**Snake River Oil and Gas, LLC**  
**117 East Calhoun – P.O. Box 500**  
**Magnolia, Arkansas 71753**

Re: Underground Injection Control (UIC) Permit Application No. ID-2D001-A – Request for a Revised Monitoring Plan

This letter transmits Snake River Oil and Gas, LLC's response to your April 5, 2021 letter requesting a revised monitoring plan.

## ATTACHMENT P: Monitoring Program

Figure P-1

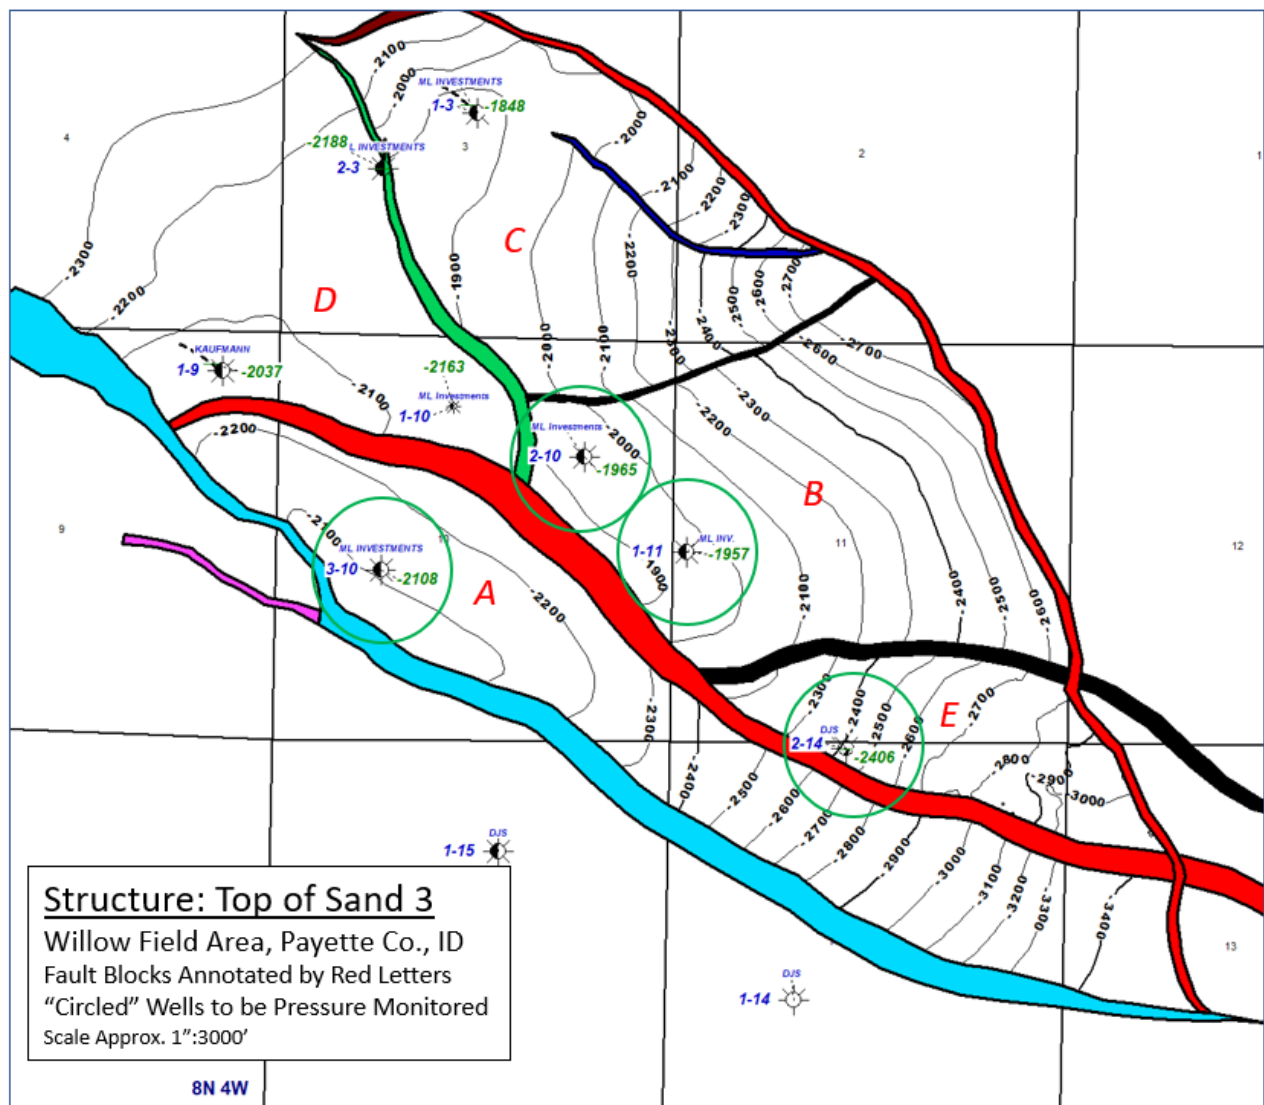
First, the current monitoring program is insufficient because it does not propose a method for evaluating the confinement of the nearest faults (i.e., the southwestern and northern faults) prior to the start of injection. While the evidence submitted to date indicates that these nearby faults are likely sealing, EPA has not received a plan for evaluating these faults prior to injection. Due to the proximity of DJS 2-14 and Block A and Block B, it is important that possible fluid communication is investigated prior to injection.

- a. To confirm that Fault Block E is currently not in hydraulic communication with Fault Block A and Fault Block B, average reservoir pressures will be measured in each fault block before beginning injection. (Refer to Figure P-1 below for a map that shows the fault blocks and wells.) Both Fault Block B and A have experienced production and consequent pressure reductions, while Fault Block E has not produced and should be at virgin reservoir pressure.

- iii. The results of these tests and all data will be analyzed and submitted to the EPA for review and approval. Separation will be shown by comparing the reservoir pressure of the DJS 2-14, in Fault Block E, to each of the reservoir pressures measured in the offset fault blocks (ML Investments 3-10 in Fault Block A, and ML Investments 2-10/ML Investments 1-11 in Fault Block B). The pressure in the DJS 2-14 should be close to a virgin pressure of a fresh water gradient (0.43 psi/ft). In addition, the pressures in each of Fault Blocks B and A should be significantly less than Fault Block E to illustrate there is no communication between the fault blocks. Assuming that Fault Block E is at virgin pressure and separation between Fault Block E and Fault Blocks A and B is apparent, SROG will request approval from the EPA to proceed with injection.

# DJS 2-14 Log Section

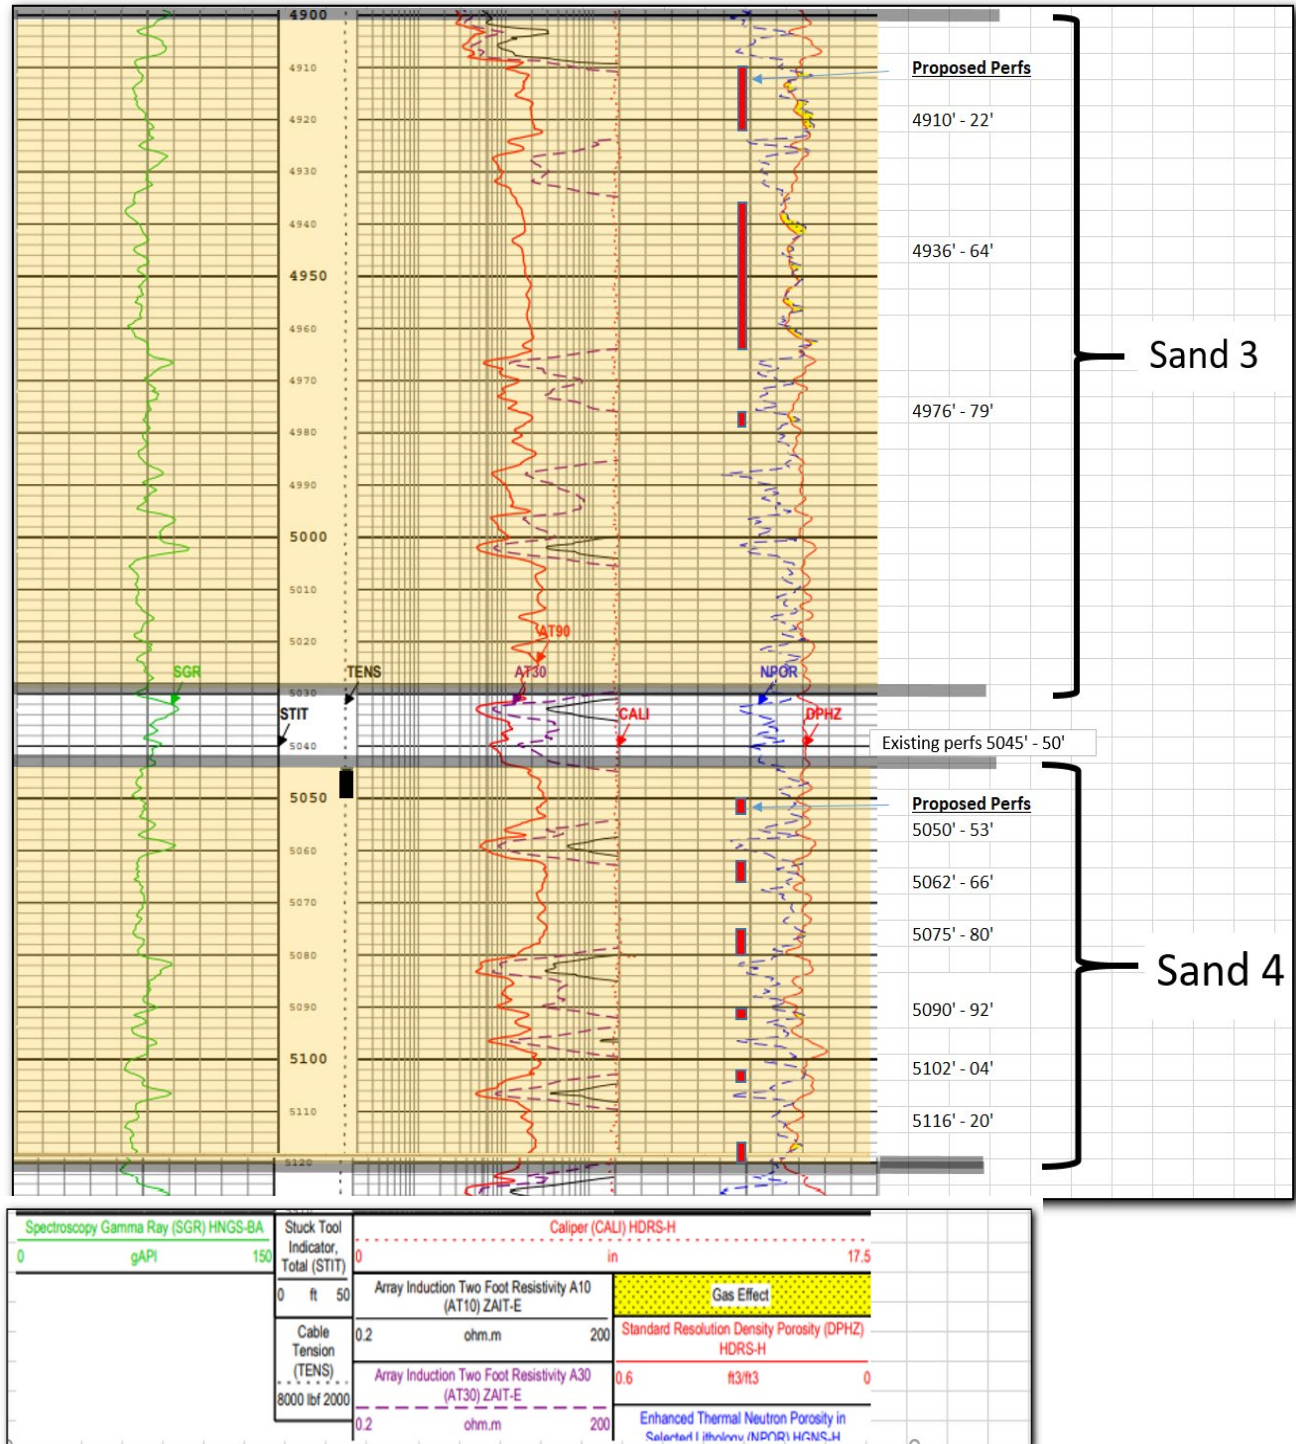
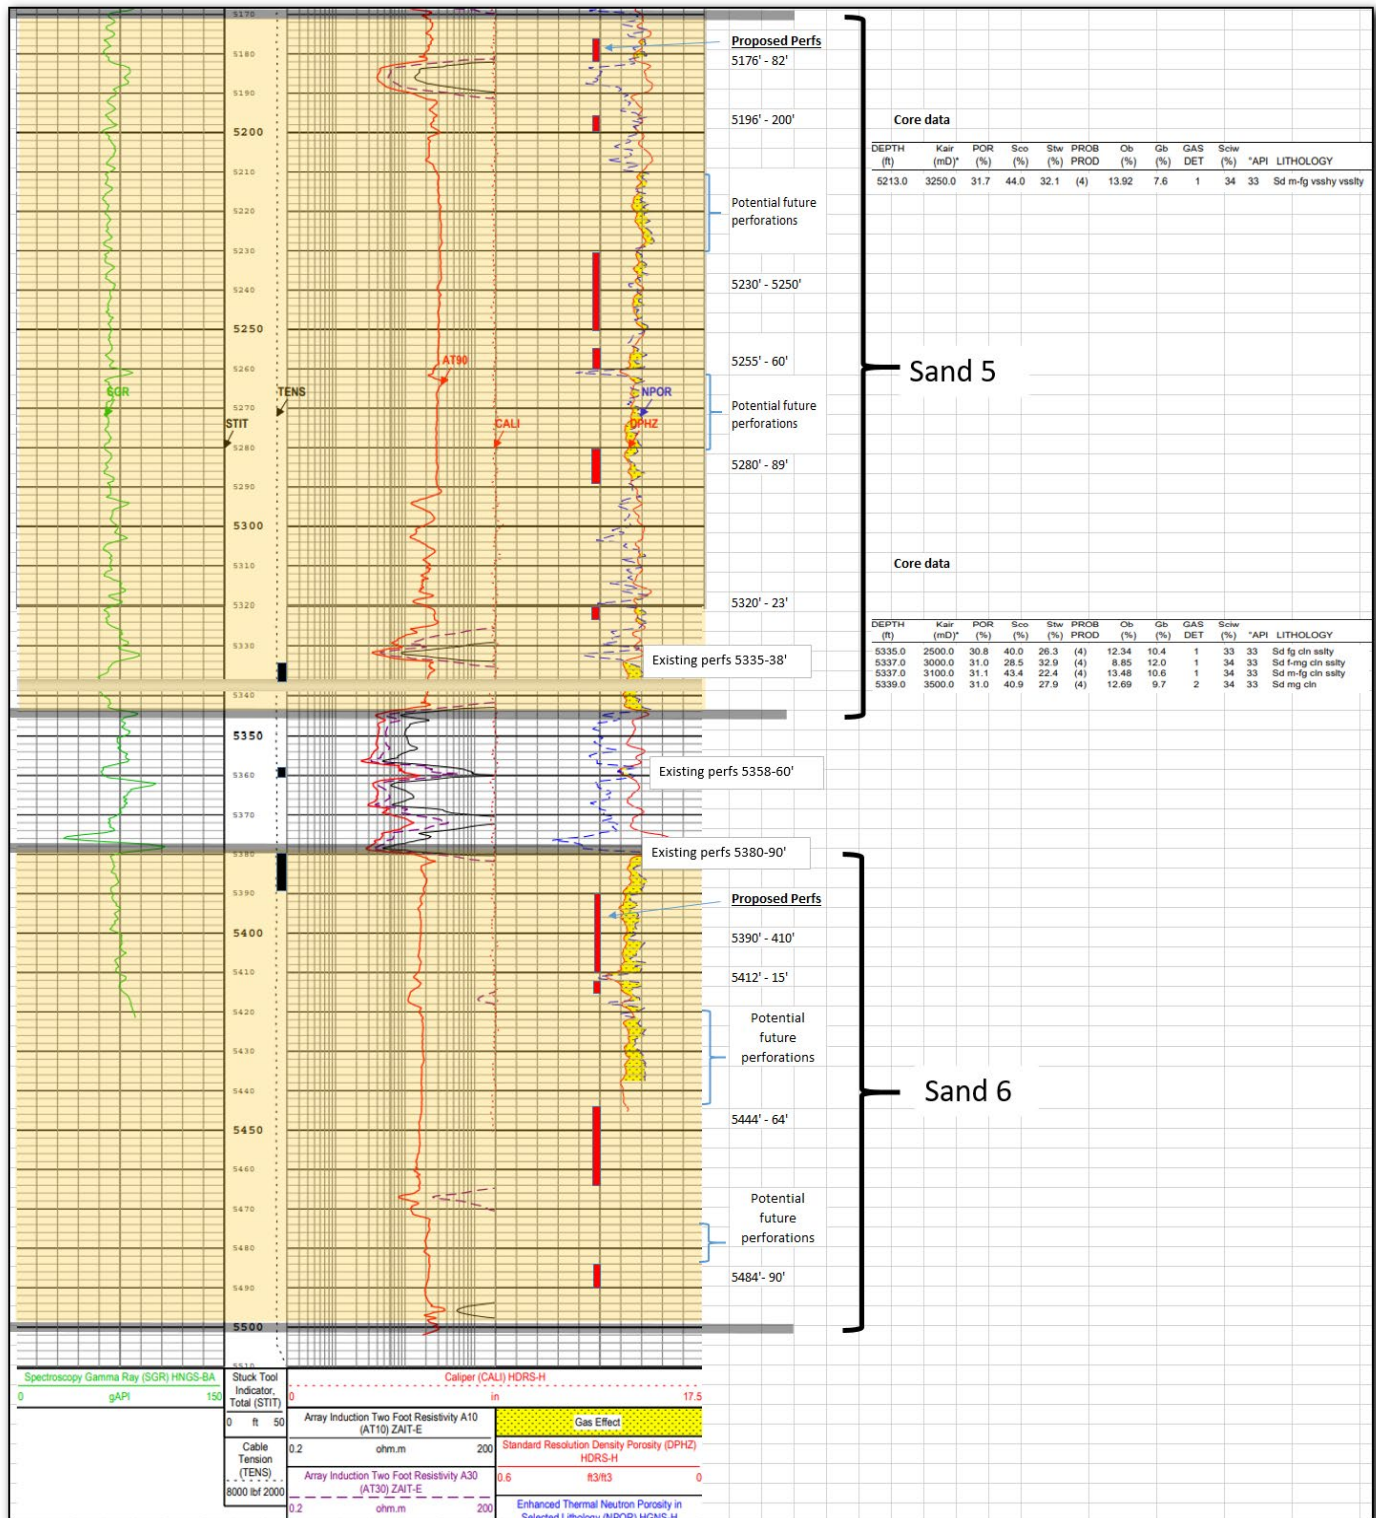
In addition, we are submitting a revised wellbore completion plan to include perforating in each of the Willow Sands to allow for injection over the entire permitted interval. This is intended to allow for hydraulic connection with the entire permeable reservoir pore space and provide for a more uniform pressure and area of injectate emplacement in the reservoir. Attachment II includes the revised Attachments L, M-5, Q-1, Q-2, and Q-3, reflecting the revised perforation intervals.

4. Add perforations:
  - a. *Sand 3*
    - i. 4,910' – 4,922'; 4,936' – 4,964'; 4,976' – 4,979'
  - b. *Sand 4*
    - i. 5,050' – 5,053'; 5,062' – 5,066'; 5,075' – 5,080'; 5,090' – 5,092'; 5,102' – 5,104'; 5,116' – 5,120'

- c. *Sand 5*
    - i. 5,176' – 5,182'; 5,196' – 5,200'; 5,230' – 5,250'; 5,255' – 5,260'; 5,280' – 5,289'; 5,320' – 5,323'
  - d. *Sand 6*
    - i. 5,390' – 5,410'; 5,412' – 5,415'; 5,444' – 5,464'; 5,484' – 5,490'

**Isopach with Circular Illustration of Area of Emplacement (7,368,000 BBL)**

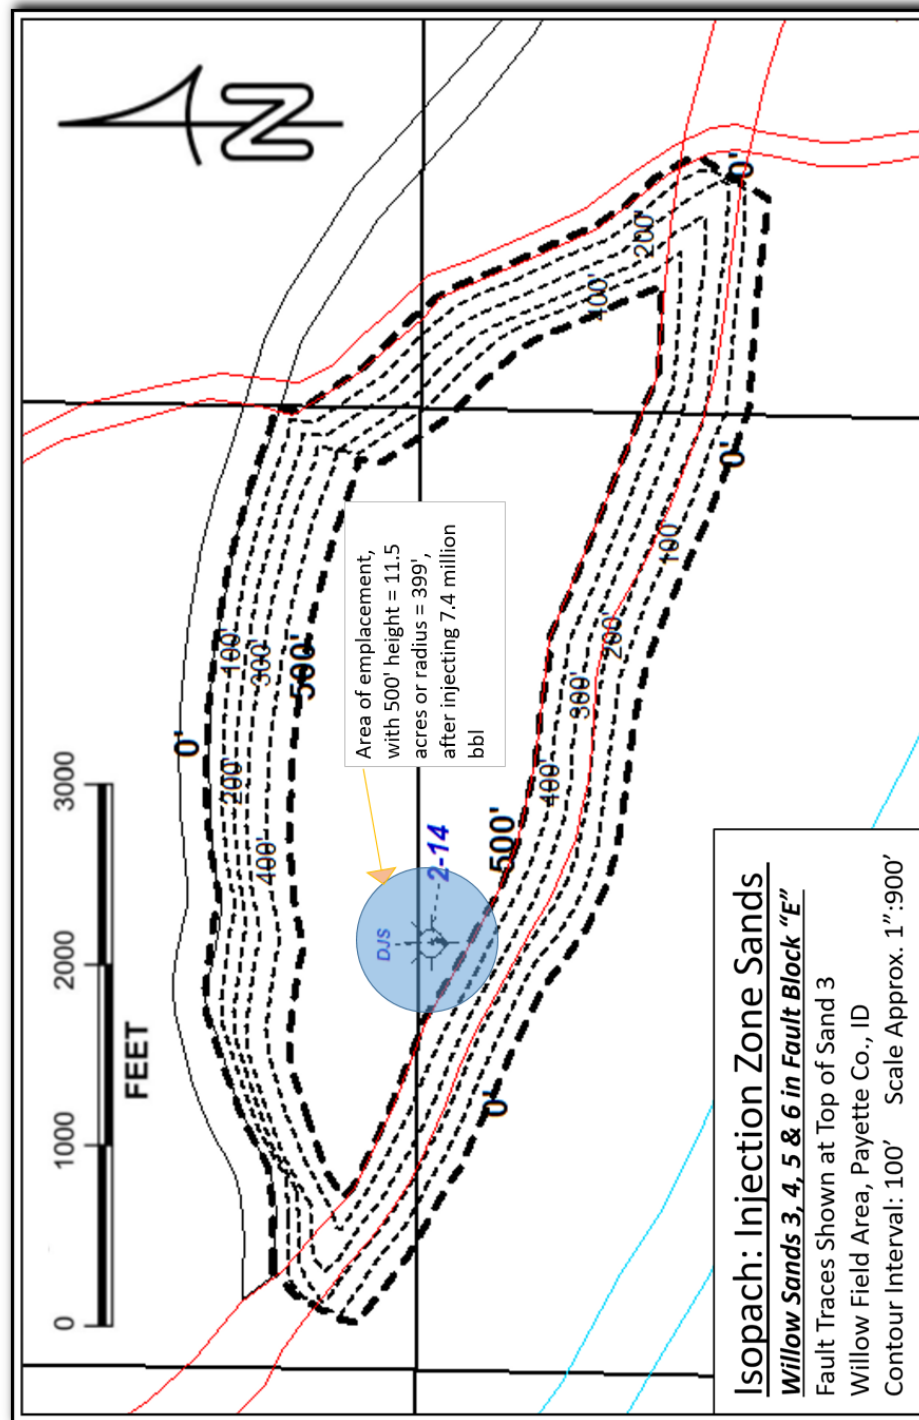
Second, the current monitoring plan does not describe how fluid movement would be monitored during the life of the well. SROG's current monitoring plan states that pressures will be monitored in offset wells to ensure they fall within "normal operating ranges," and to stop injection operations immediately once "abnormalities" are noted. This plan is insufficient because it is not sufficiently descriptive. It does not define what would be considered abnormalities outside of normal operating ranges, nor does it explain how these abnormalities would relate to fluid movement in Block E. It is also unclear what effect ongoing fluid production from Blocks A and B would have on downhole monitoring, or how the distance between these existing wells and DJS 2-14 would impact detection of movement out of Block E. A plan that includes monitoring of bottomhole pressures needs to explain how that monitoring would identify movement across the specific fault boundaries forming Block E.

The Area Of Emplacement, as defined here is the portion of the injection reservoir that is occupied by injectate, when viewing the reservoir from a top-down vertical view. As produced water is injected into the pore space in the reservoir, mobile reservoir fluids are assumed to be displaced by the injectate. For this illustration, it is assumed that the displacement is uniform and 100% efficient, providing a simple solution for determination based on the final geometrical shape of the emplacement. In this case, since the gas saturation of 20% is assumed to be residual and immobile, the gas saturation serves to reduce the available pore space available for emplacement. The area of emplacement is calculated and shown below based on a simple volumetric method, with no consideration of compressibilities, and assuming a homogenous reservoir of uniform porosity and permeability. Note that the effect of ignoring compressibilities causes the area calculated to be slightly larger than actual. Each of the gas, water and matrix compressibilities would create a smaller area of emplacement than is shown here. The assumption made is that the AOE will conform to a cylinder with the axis about the wellbore, appearing as a circle in map view. The vertical height of the emplacement is simplified by utilizing the isopach thickness seen in the DJS 2-14 well. For this illustration, the circle is centered over the well. Note that southwestern portion of the circle impinges on the isopach wedge below 500' thickness. No effort was made to account for this, since the main point of this calculation and display is to illustrate the relative areas of the emplacement versus the area of the isopach. As shown below the area of emplacement is approximately 11.5 acres versus the total reservoir area of 269 acres. Note that this AOE is for a total injected volume of approximately 7.36 MMBW.
